Access Compliance Report

Public Rights-of-Way

(Curb Ramps)

Intersection ID: 9140	Main Street: FREEDOM_DR	Cross Street: THRIFTWOOD_DR	Location: NW
ADA ID: 10AFE9057D84	Ramp Type: BlendTrans1	Initial Pass/Fail: Fail	Overall Compliance: No
		Severity Score: 8.75

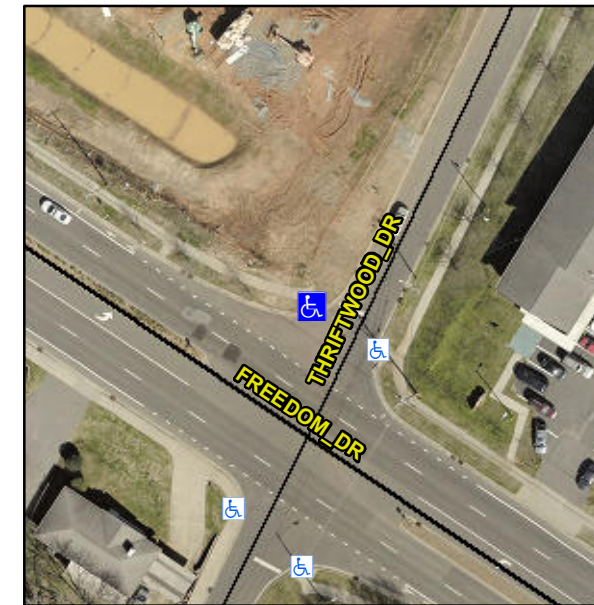
NO RT SW

Not Found, R304.5.1

Remove & Replace Curb Ramp With Two New Directional Ramps or Equivalent.
